Model: Model U-P1		Date: 19-Dec-02	No.: MG071001
Modified Article: Parts Catalogue		Prepared by: H.K.	
From: Technical Services sec. Service Planning Dept.			
Reason for Modification:	<input checked="" type="checkbox"/> Parts catalog correction <input type="checkbox"/> To facilitate assembly <input type="checkbox"/> Part standardization	<input type="checkbox"/> Vendor change <input type="checkbox"/> To improve reliability <input type="checkbox"/> Other	<input type="checkbox"/> To meet standards ()

Model: Model U-P1		Date: 27-Dec-02	No.: MG071002
Modified Article: Development uint - MYC		Prepared by: H.K.	
From: Technical Services Sec. Service Planning Dept.			
Reason for Modification:	<input type="checkbox"/> Parts catalog correction <input type="checkbox"/> To facilitate assembly <input type="checkbox"/> Part standardization	<input checked="" type="checkbox"/> Vendor change <input type="checkbox"/> To improve reliability <input type="checkbox"/> Other	<input type="checkbox"/> To meet standards ()

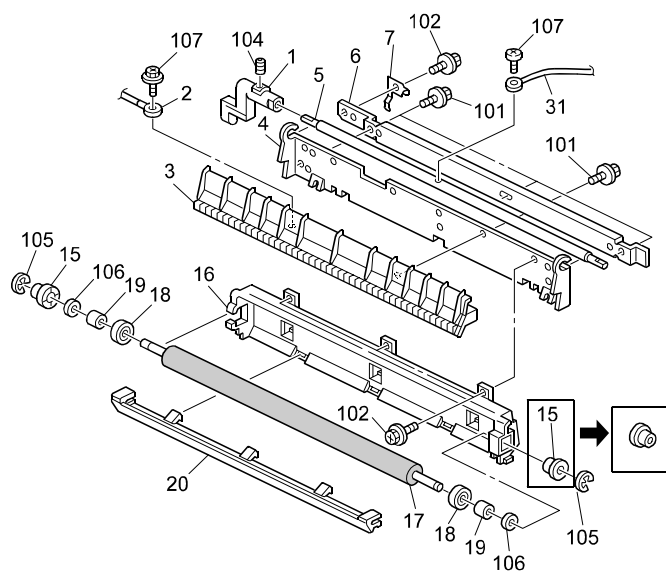
Old part number	New part number	Description	Q'ty	Int	Page	Index	Note
G0703501	G7823025	Development Unit - M Ass'y	1	O/O	27	22	
G0703502	G7823026	Development Unit - Y Ass'y	1	O/O	27	20	
G0703503	G7823027	Development Unit - C Ass'y	1	O/O	27	21

Due to a vendor change, the P/N for the M, C and Y Development Units have been changed.

Fig. 1

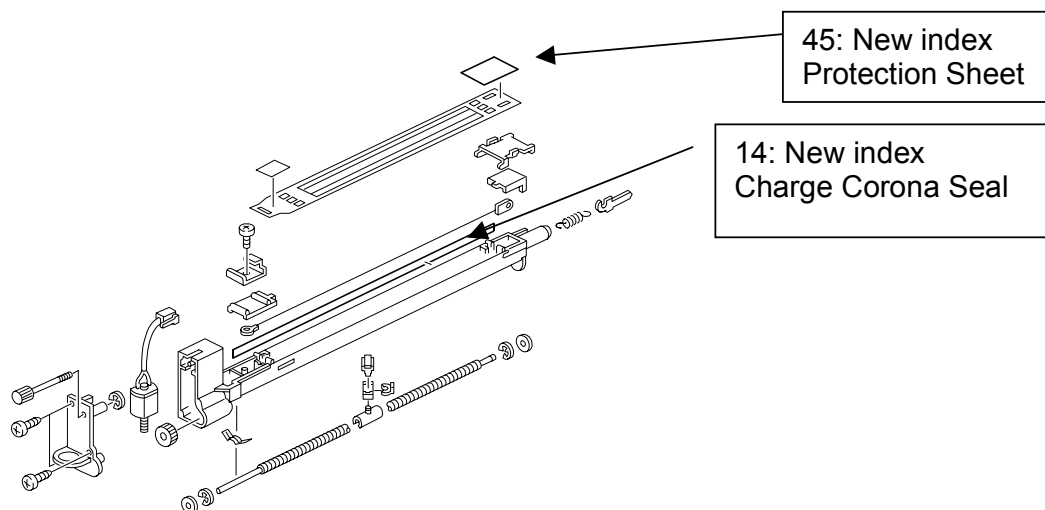
- The material of the charge corona seal has been changed to reduce the friction between the seal and OPC belt.

Note: The charge corona seal is not included in the P/C illustration on pg. 24, so please apply the correction shown below in Fig. 1. Also, the old part number is not listed on pg. 25, so please add the new part number and index number listed above to this list.

- To reduce the possibility of damaging the OPC belt when the charge corona unit is removed from and installed into the PCU, a protection sheet has been added to the rear end of the charge corona grid (see Fig.1).

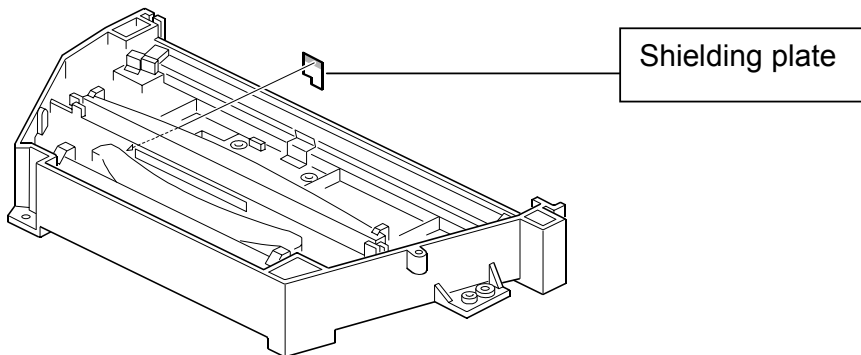
To improve image quality, a Shielding Plate has been added for filtering out excessive light.

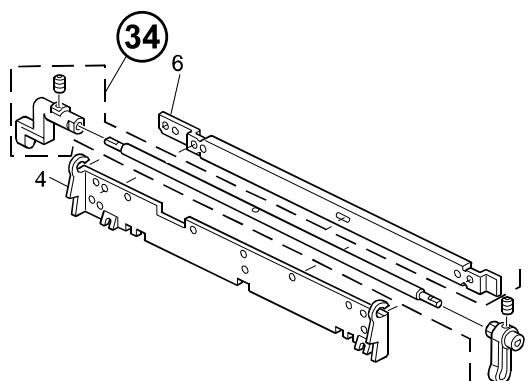
The Front Arm, Rear Arm and Arm Shaft have been combined into one assembly to ensure that the shaft is level when attached, because this is difficult to achieve when installing the individual components without a factory tool.

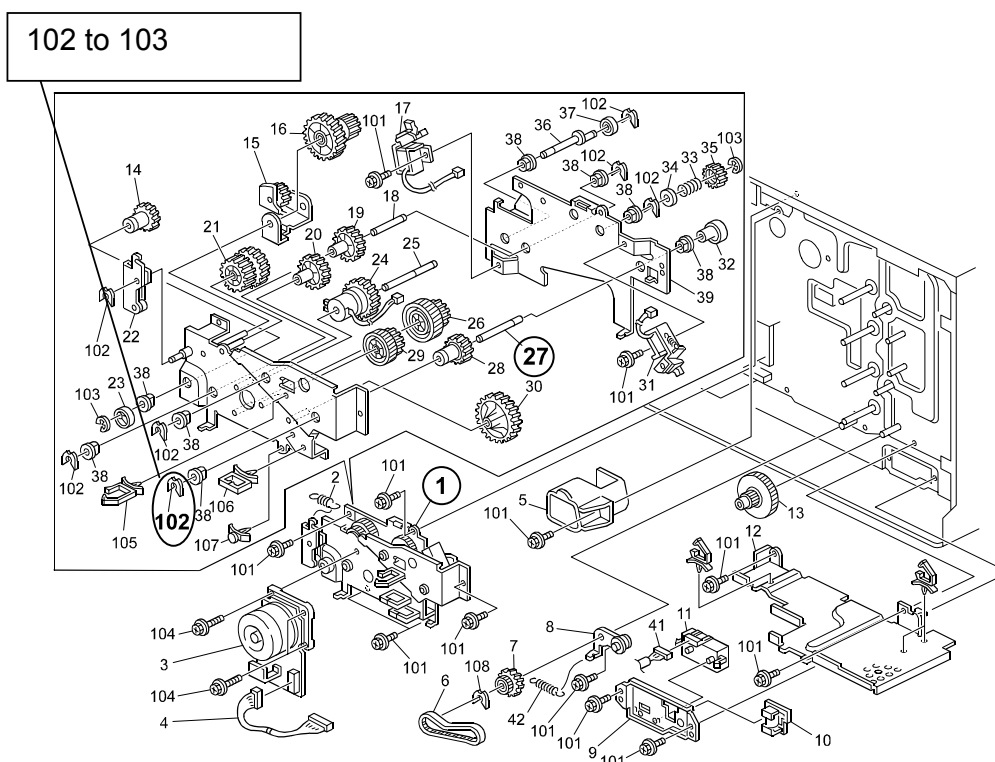
The following have been changed to further ensure proper function of the cam (G0704829) by minimizing the possibility of an excessive load placed on the cam.

Note: When installing for the first time, parts (AA145563) and E-ring marked index 102 should be changed together **as a set**.

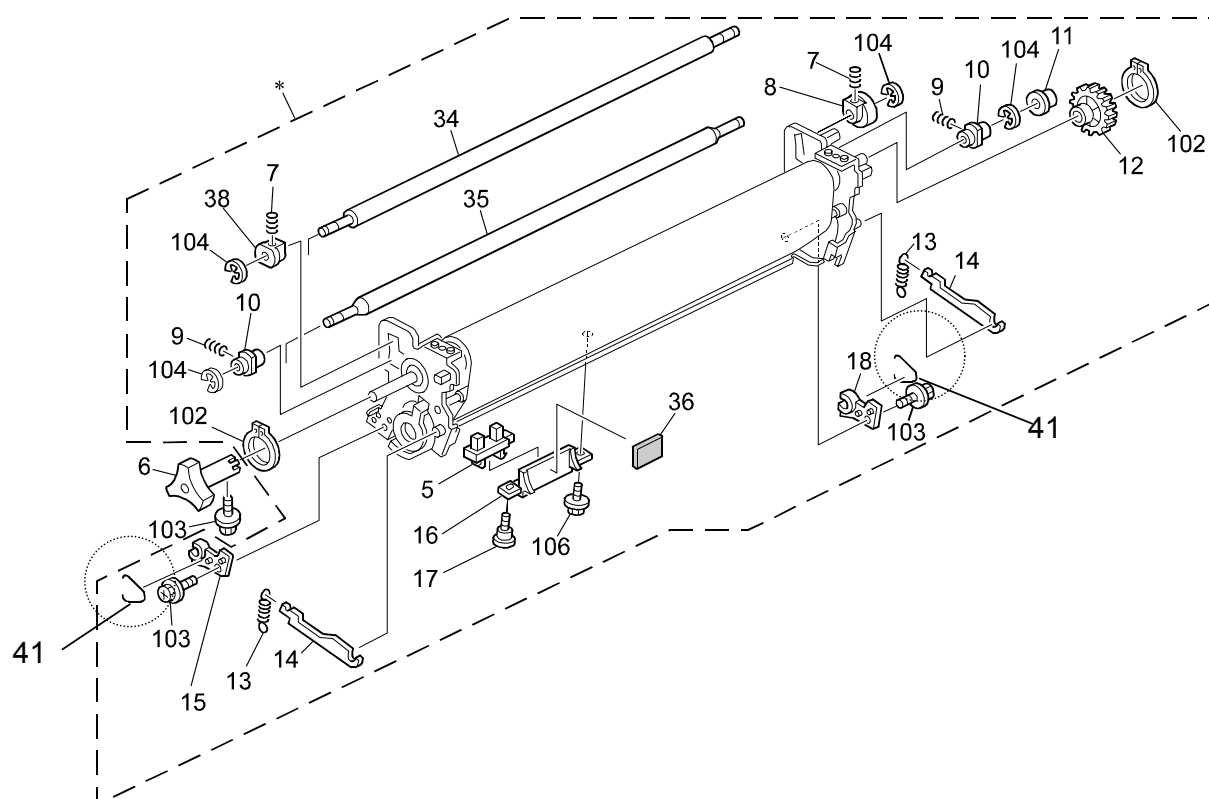
Please add the following information, which was previously missing from the Parts Catalog.

Old part number	New part number	Description	Q'ty	Int	Page	Index	Note
	G0704153	Stopper Spring	2		30	41

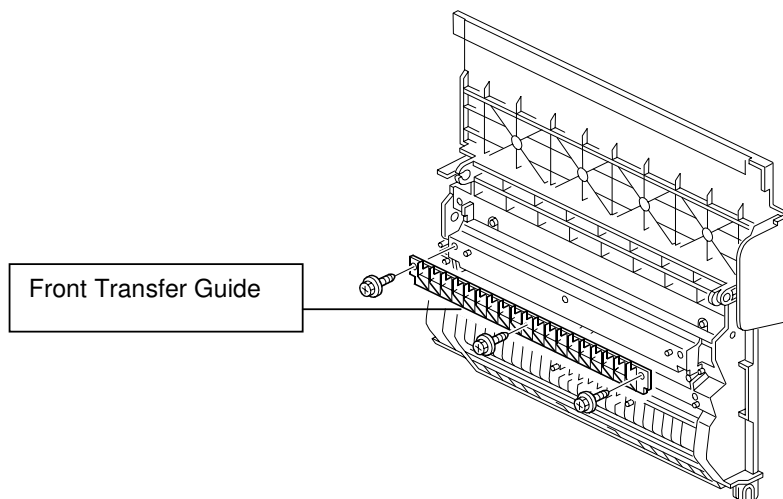
Incorrect part number	Correct part number	Description	Q'ty	Int	Page	Index	Note
	B0511365	Front Transfer Guide	0 - 1		21	*33

The Front Transfer Guide was added as it was previously missing from the Parts Catalogue.

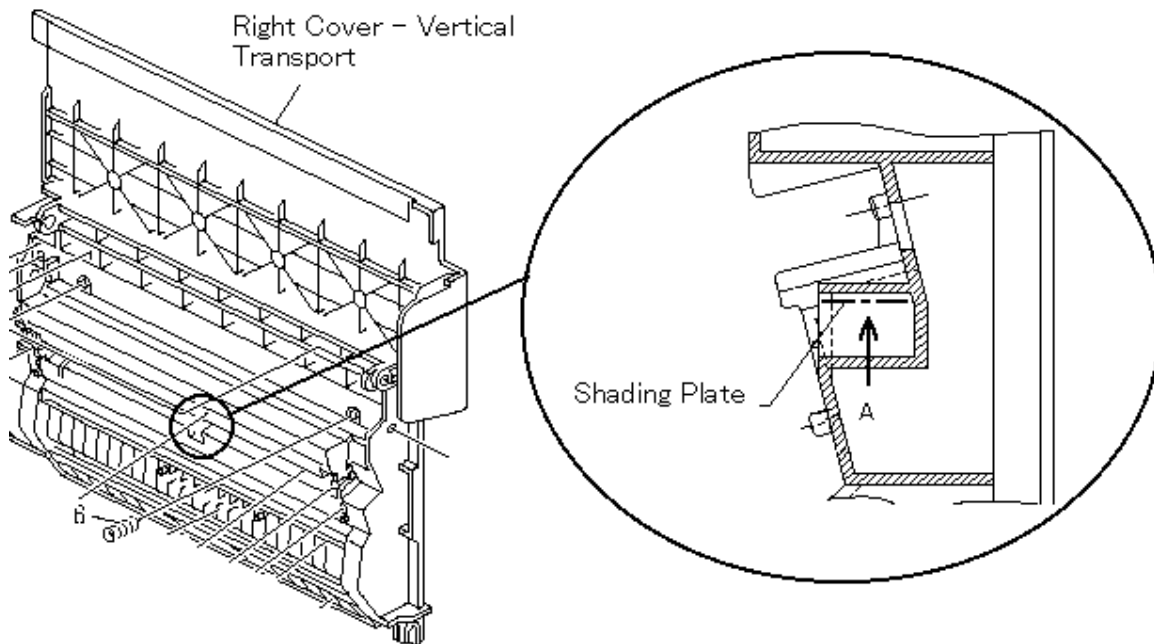
A black shading plate has been added to the vertical transport right cover, which will further ensure proper paper feed by preventing registration sensor misdetections caused by light diffused by paper dust.

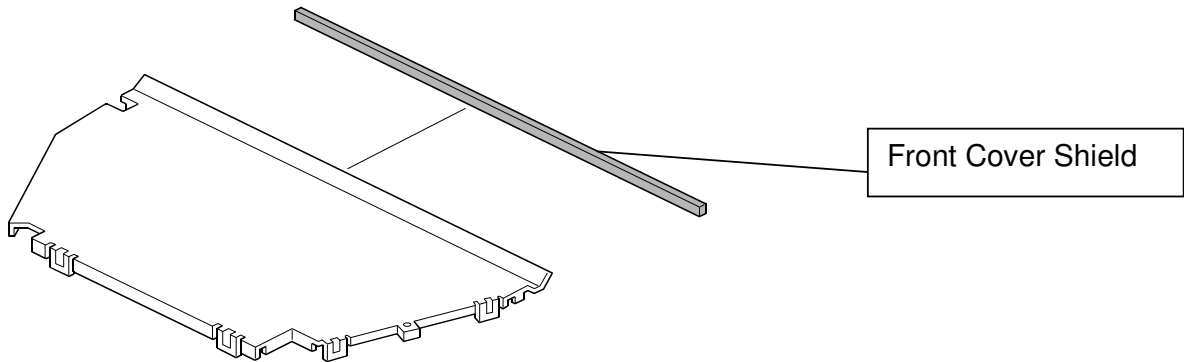
The following is the correct illustration for the front cover shield (P/N G0701942, pg. 23, index #2).

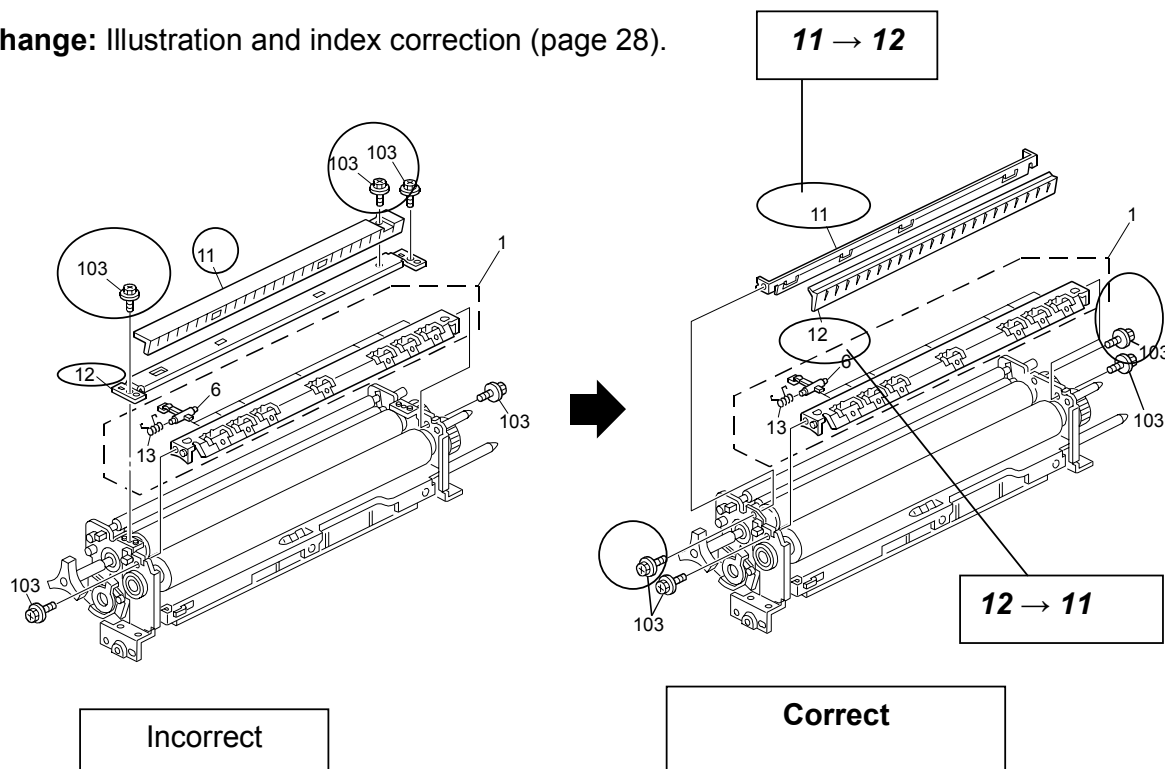
Change: Illustration and index correction (page 28).

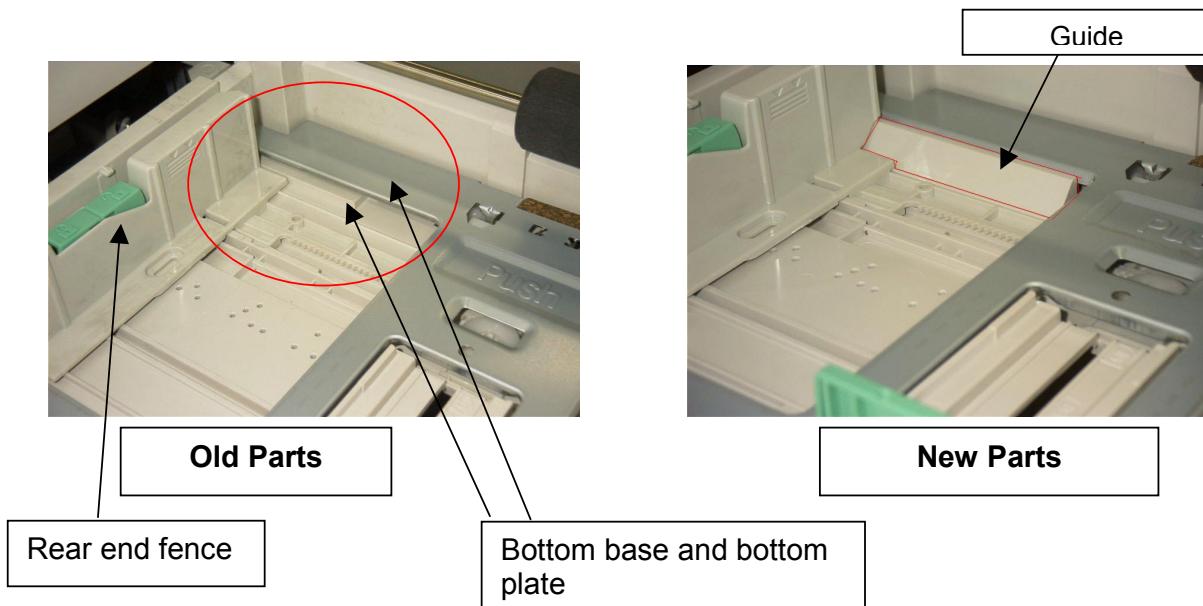
- 1) Two guides were added to the bottom base of the paper tray
- 2) The shape of the side fences was changed

Reason: To make it easier to load the paper in the tray. This ensures that paper does not get caught in the gap between the bottom base and bottom plate.

Important: If the old side fence needs to be replaced, install the new paper tray (B0512711).

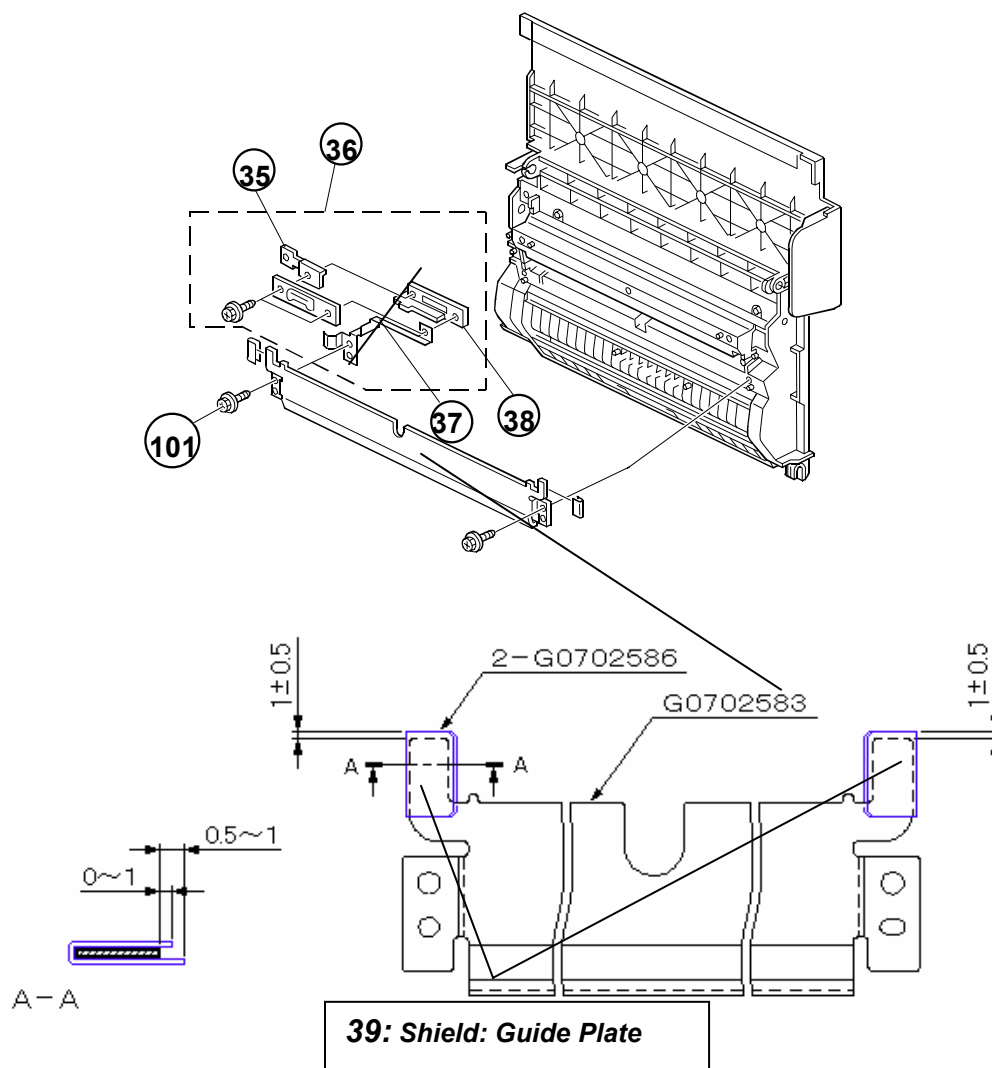
Change: The parts in the table were added.

Reason: To further improve the image transfer for paper with a high moisture content.

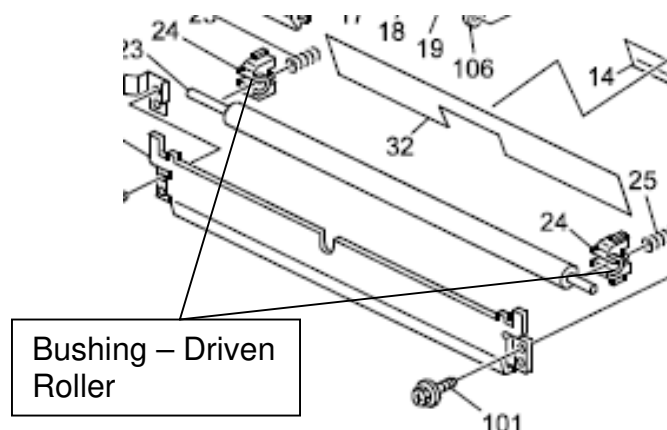
Change: 1) The material of the bushings was changed.
 2) A ground plate was added.

Reason: To further improve the accuracy of the image transfer mechanism.

Important: When you use the parts for the first time, replace them together as a set.

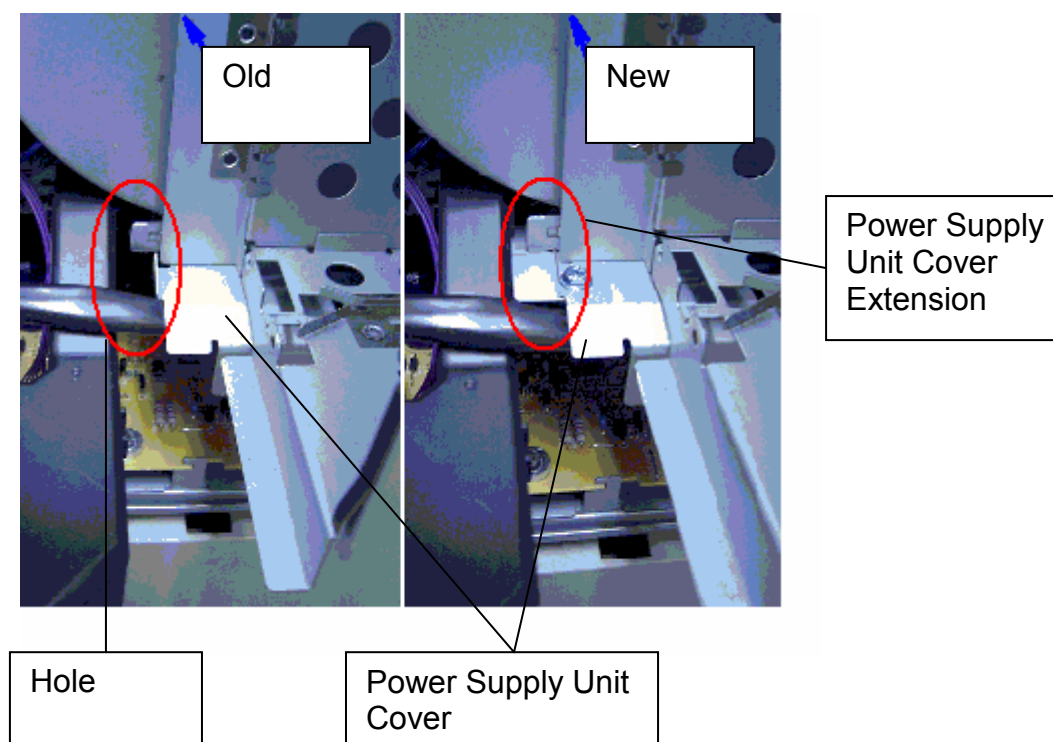
A screw hole was made in the power supply unit cover. A small extension to the power supply unit cover, attached with a screw, was added and assembled together with the power supply unit cover.
